Appeal Against Conditions 1 and 4 Attached To Grant of Revised Fire Safety Certificate (Reg. Ref. FS 52/15)

The Pavillion, The Glenlo Abbey Hotel, Kentfield, Busypark Co. Galway

Client	:	An Bord Pleanala
An Bord Pleanala Ref No	:	FS 06D.FV0008
GCC Reg Ref	:	FS 120/14
Our Ref.	:	16107-FS 06D.FV0008 -R01.
Date	:	29 th January 2016

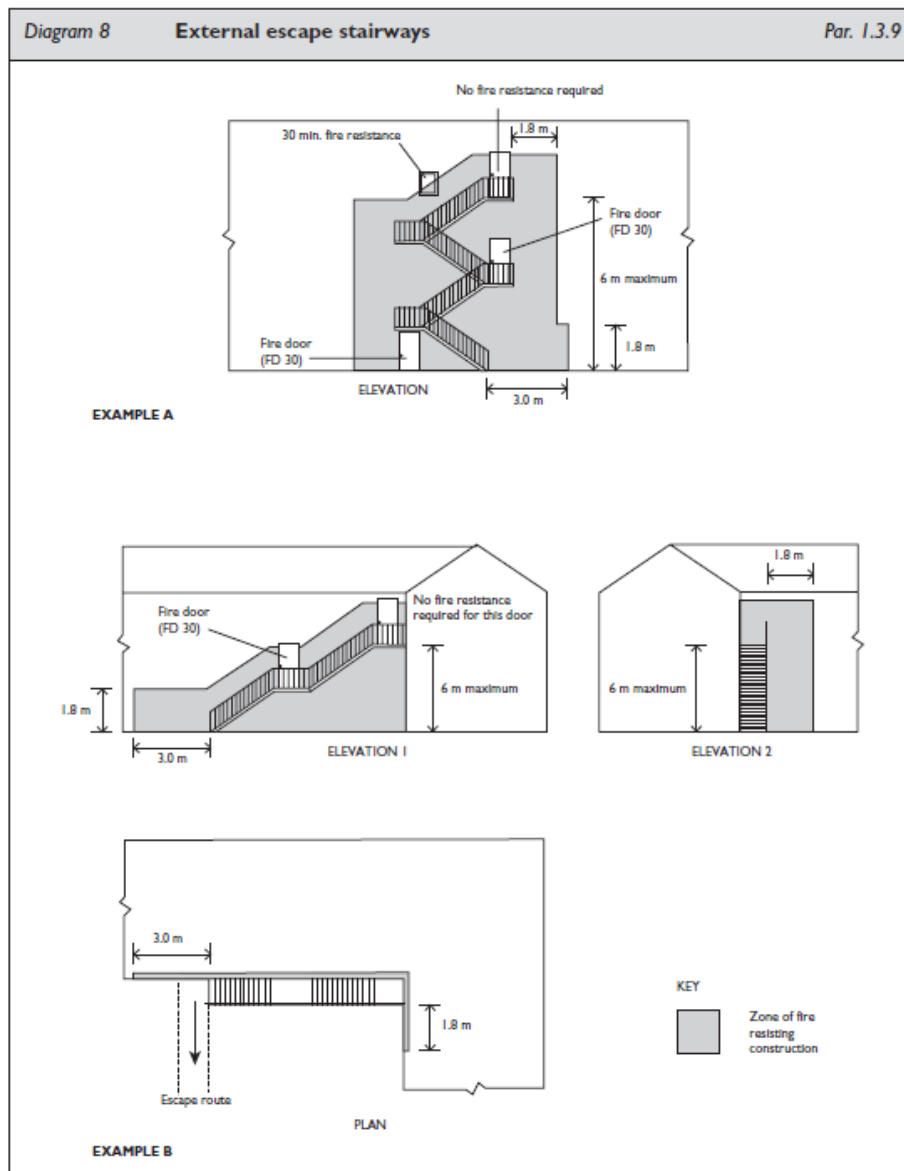
The fire officer dismisses the case made by the appellant that the situation is similar to the residential guidance given the differences in occupancy levels and compartmentation.

The response goes on to state that in his opinion should a plume flow over the edge of the balcony it would more likely pull the smoke over the edge of the balcony thus rendering it impassable.

The fire officer states that there is some half hour subdivision at ground floor and states that Diagram 8 from Technical Guidance Document B does not take into account compartmentation.

While Diagram 8 does refer to external escape stairs its requirements are designed for open unprotected external stairs and does not take into account where the stair is providing a fire and smoke resistance.
